Contract #: 04-0120F4Cty: SF/ALA Rte: 80 PM: 13.2/13.9File #: 69.25B**QUALITY ASSURANCE -- NON-CONFORMANCE REPORT****Location:** Chanxing Island, Shanghai, PRC**Report No:** NCR-000365**Prime Contractor:** American Bridge/Fluor Enterprises, a JV**Date:** 20-Jun-2009**Submitting Contractor:** Zhenhua Port Machinery Company, Ltd (ZPMC), Changxing Island**NCR #:** ZPMC-0339**Type of problem:**

Reference Description: Heat Straightening without Engineer's approval**Description of Non-Conformance:**

Job Name: SAS Superstructure

Subject: NCR No. ZPMC-0339

项目名称 Project Name	美国海湾大桥 SFOBB	部件图号 Drawing No	SEG032	报告编号 Report No.	B-WR5645
合同号 Contract No.:	04-0120F4	部件名称 Items Name	6CE顶板 6CE Deck Plate	NDT报告编号 Report No.of NDT	NA
项目编号 Project No.:	ZP06-787

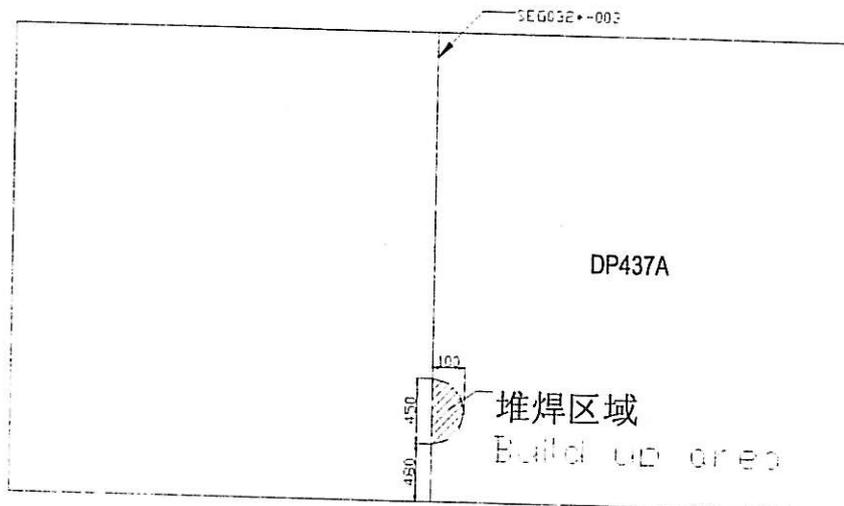
完工报验时发现, 顶板对接焊缝SEG032*-003有局部变形, 现场已经将低洼处做堆焊处理, 具体位置见下图!

After final inspection, deck plate butt weld (SEG032*-003) was part distortion, and it build up the low-lying area, the detail see the following draft.

1. 准备一个正确的接头型式，具体参照相应的返修WPS;
 2. 将碳刨区域打磨光滑，开始和结束的接头交错布置;
 3. 对修补区域进行VT与MT检测;
 4. 根据批准的返修焊接工艺规程 (WPS) 进行预热及焊接;
 5. 将修补区域打磨与母材或相邻焊缝平齐;
 6. 对修补区域作100%VT与MT检测;
-
1. Prepare excavation according to the approved repair WPS.
 2. Grind the gouged area to a smooth and shiny finish, with tapered ends, to ensure staggered starts and stops.
 3. VT and MT the repair area.
 4. Preheat and weld according to the relevant repair WPS.
 5. Grind the repaired area flush with base metal or the adjacent weld.
 6. Perform VT and MT over 100% of the repair area.

项目名称 Project Name	美国海湾大桥 SFOBB	部件图号 Drawing No	SEG035*	报告编号 Report No.	B-WR5495
合同号 Contract No.:	04-0120F4	部件名称 Items Name	顶板 Deck Plate	NDT报告编号 Report No.of NDT	NA
项目编号 Project No.:	ZP06-787

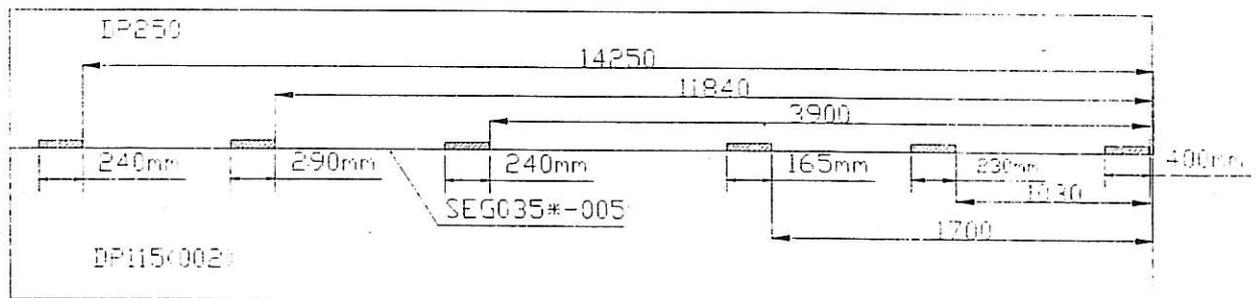
经检查发现7BW顶板三拼后, DP250与DP115(002)焊接后有六处变形错位, 其中最大变形量为10mm, 涉及焊缝为SEG035*-005, 具体位置及长度如下图所示:

After inspection 7BW DP250 and DP115(002) deck plate splice, it was six position misalignment, maximum 10mm, weld No.: SEG035*-005, the detail see the following draft.

1. 采用火焰切割的方法从顶板对接错边位置割开长度L, L根据现场错边情况而定;
 2. 根据批准的WPS准备焊接接头型式;
 3. 采用工艺卡码及千斤顶调整顶板错边量, 并进行定位;
 4. 焊接前对坡口进行VT与MT检测确认无缺陷存在;
 5. 根据批准的WPS进行预热及焊接顶板焊缝;
 6. 将返修处焊缝打磨与母材或周边焊缝平齐;
 7. 焊后根据图纸要求对焊缝作NDT检测;
-
1. Cut the weld between deck plates with a certain length L which begin with misalignment emerging by flame cutting, L is conformed by actual condition.
 2. Prepare the excavation according to the approved WPS.
 3. Adjust the misalignment of deck plates to meet the tolerance by assistant support and jack, and tack weld.
 4. Perform VT and MT inspection to the groove to ensure no defects exist prior to welding.
 5. Preheat and weld the butt joint between deck plates according to the approved WPS.
 6. Grind the welds flush to the adjacent welds or base metal.
 7. Perform NDT according to the shop drawings.
